TRANSIT EFFECTIVENESS PROJECT Responses to Comments

**City and County of San Francisco Planning Department
Case No. 2011.0558E**

DATE: March 13, 2014
TO: Members of the Planning Commission and Interested Parties
FROM: Sarah B. Jones, Environmental Review Officer
Re: **Attached Responses to Comments on Draft Environmental Impact Report Case No. 2011.0558E Transit Effectiveness Project**

**RESPONSES TO COMMENTS
TRANSIT EFFECTIVENESS PROJECT
PLANNING DEPARTMENT CASE NO. 2011.0558E**

Line 10 - Sansome

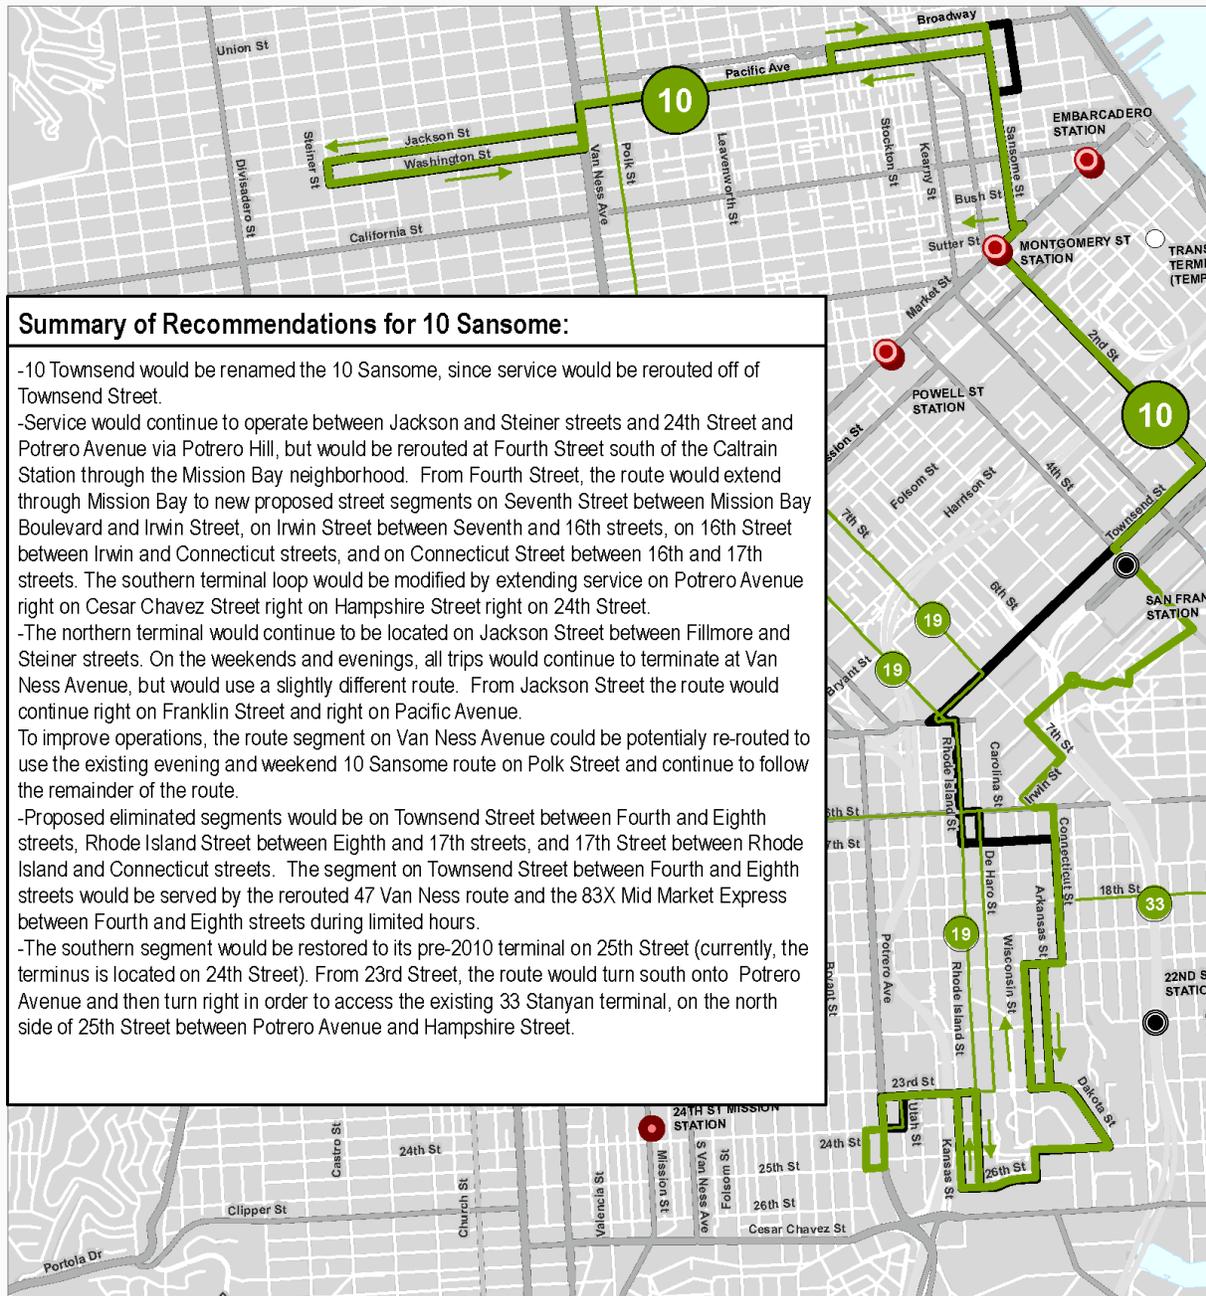
The Line 10 – Sansome Service Improvement Map provided in Initial Study Appendix A, Service Improvement Maps, has been revised to clarify the embedded text and graphic for the weekend and evening variation on the existing loop on the northern segment of the route in the vicinity of Van Ness Avenue.
